RD 2035/WDCWA JOINT INTAKE AND FISH SCREEN

Initial Study/Environmental Assessment Addendum #1

Prepared for
Reclamation District 2035
United States Bureau of Reclamation

July 2014

Figure 1
May 2012 RD 2035/WDCWA Joint Intake and Fish Screen Project Final IS/EA
Figure 2-1 – Proposed Site Plan

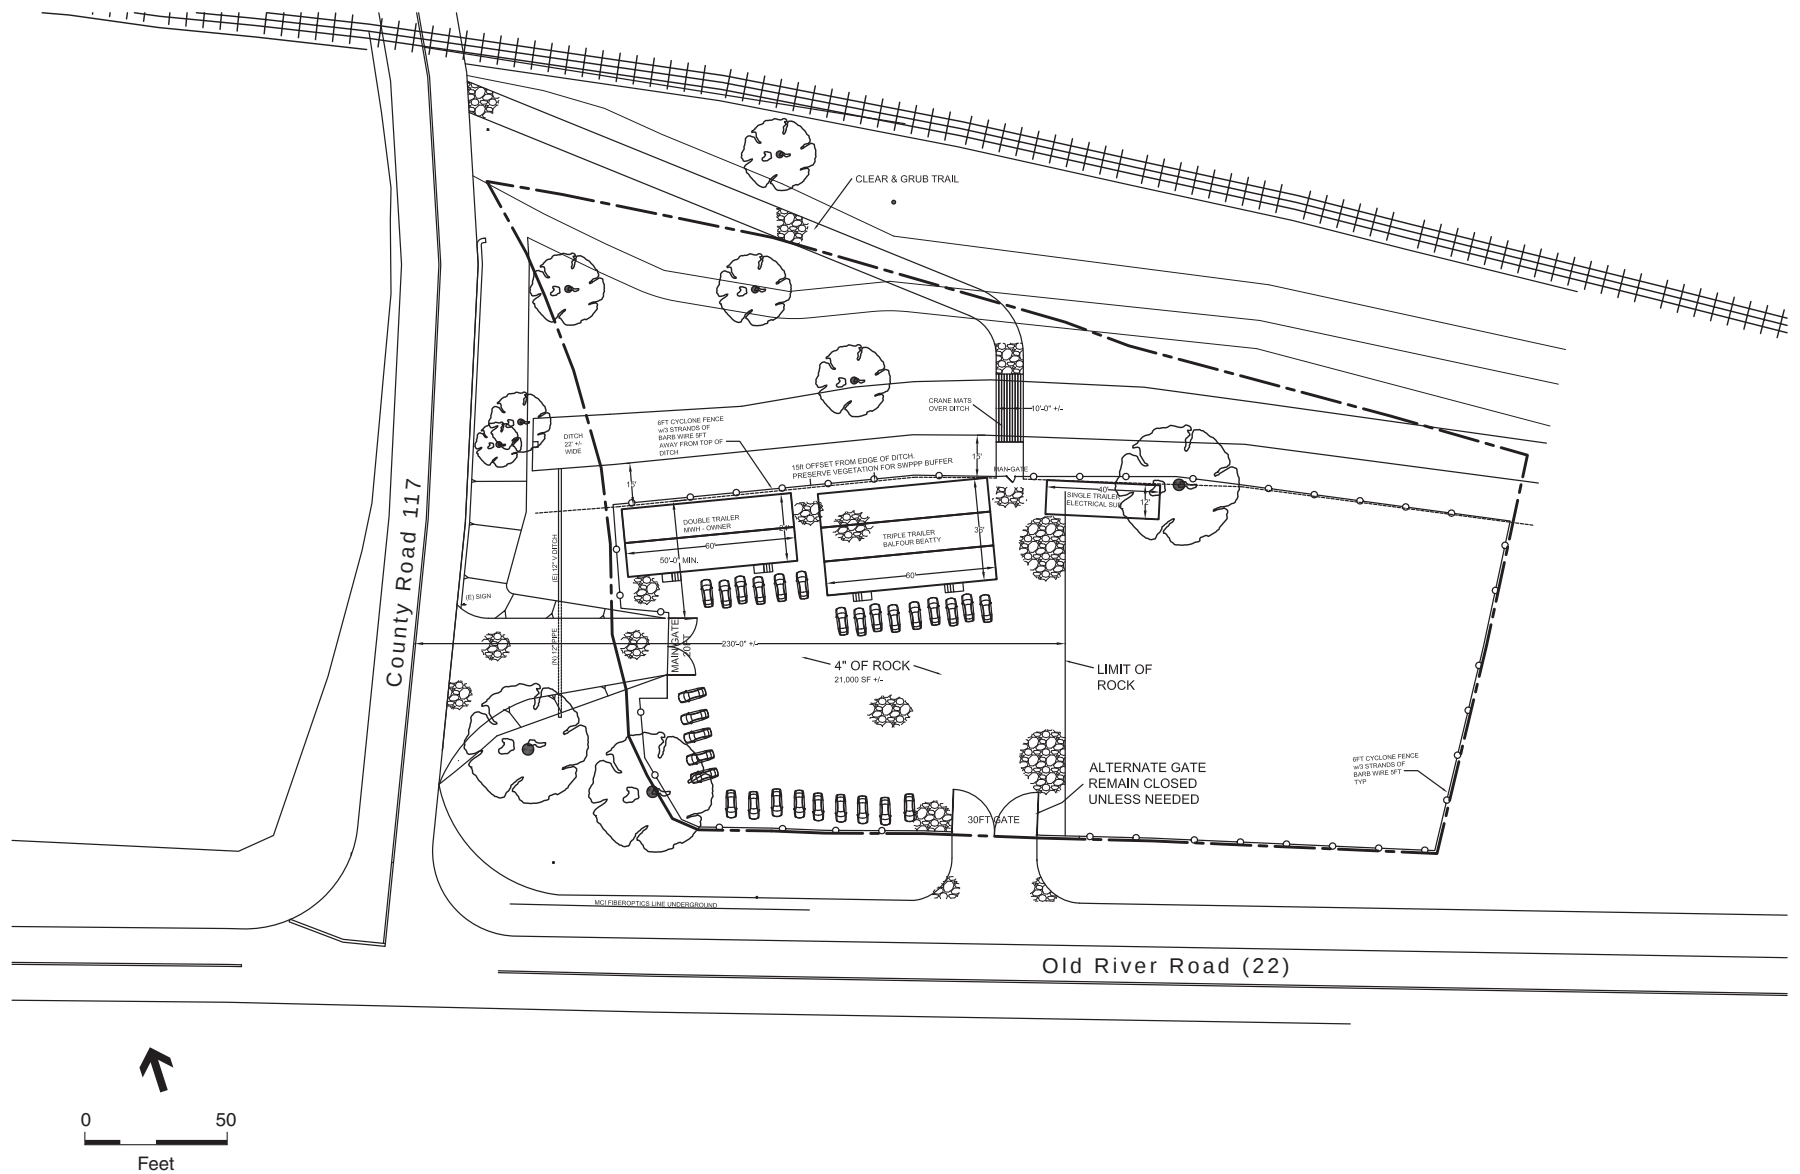
RD 2035 has identified the need for additional space for a contractor laydown site. The proposed laydown site is located east of County Road 117 and north of Old River Road in the vicinity of Interstate 5 (I-5) in Yolo County, CA and is shown in Figure 1 and Figure 2. The property owner of this parcel plans on converting the site to support their agricultural operations. Balfour Beatty Infrastructure, Inc. proposes to rent the site from the property owner for use as a laydown site for construction equipment, materials, and contractor trailers. Site preparation for the laydown area will require the removal of two trees over 12-inches in diameter. Approximately 21,000 square-feet of area will be covered with rock (520 tons). All of this work is being done by the property owner and will be left in place and used by the property owner for their future use as part of an agricultural yard. A biological site assessment and survey was conducted for the site and is included as Appendix A of this addendum.
